Service Letter No. 454

SUBJECT: Pitch Breakaway Ball Bracket (AltiMatic II)

MODELS AFFECTED: PA-23-250 (six place) with AltiMatic II

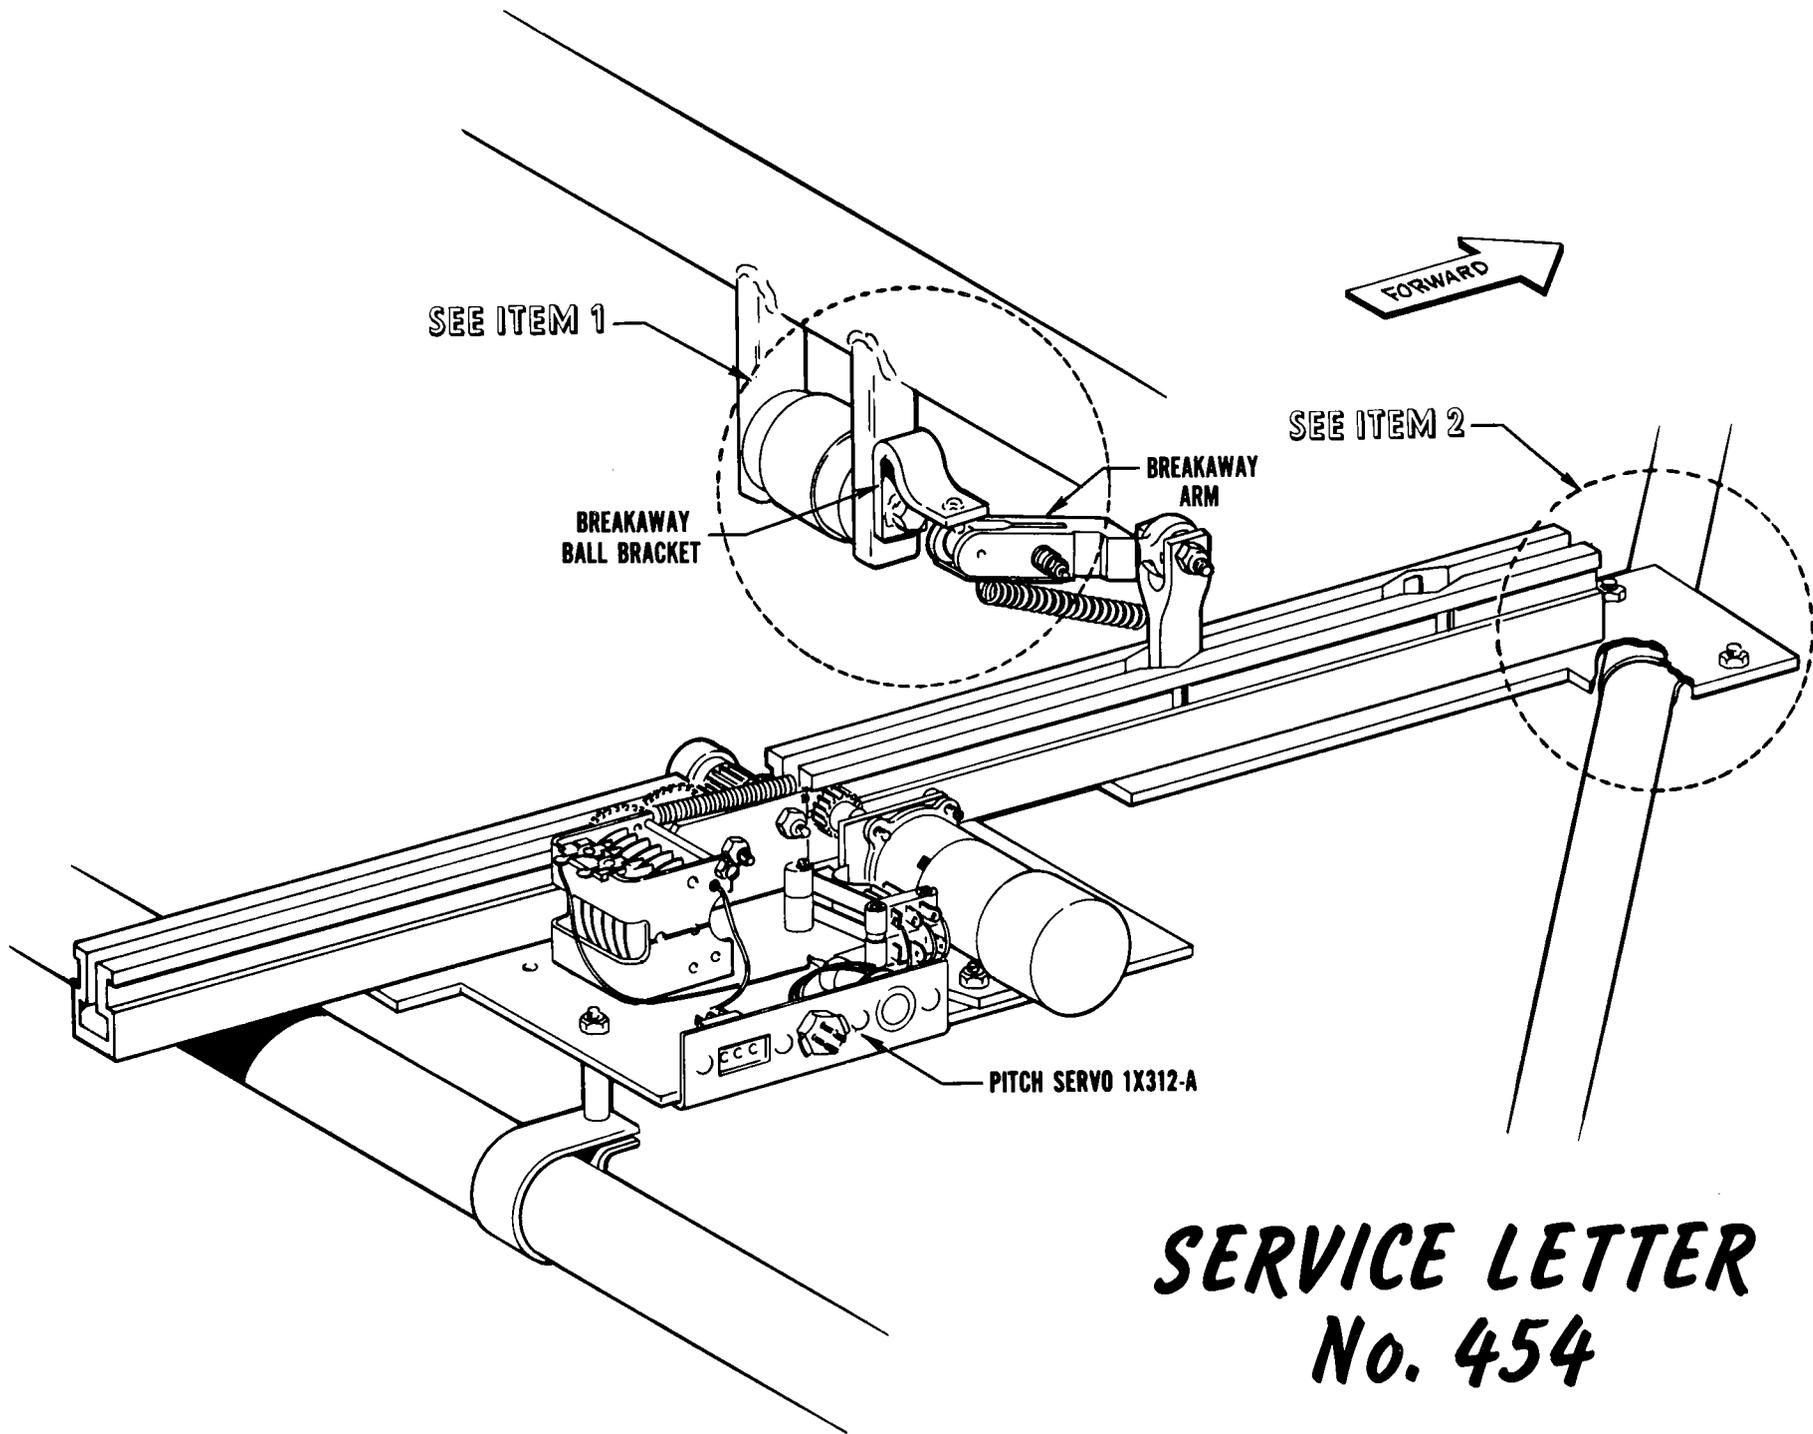
2. The forward end of the Pitch Servo (toward the bulkhead) must be mounted on the top of the fuselage tubes. All installations which have the servo mounted below the fuselage tube shall be reworked per drawing #31670, Rev. F. or per sketch on reverse side of this letter.

- 2-A. After servo has been reinstalled to comply with Item 2, if necessary, re-engage breakaway link.
- 2-B. Time pitch follow-up condenser as per EL-32A.
- 2-C. Adjust pitch leveling condenser as per ground setup outlined in EL-32A.
- 2-D. Flight check and adjust pitch leveling condenser as per in-flight adjustments outlined in EL-32A.
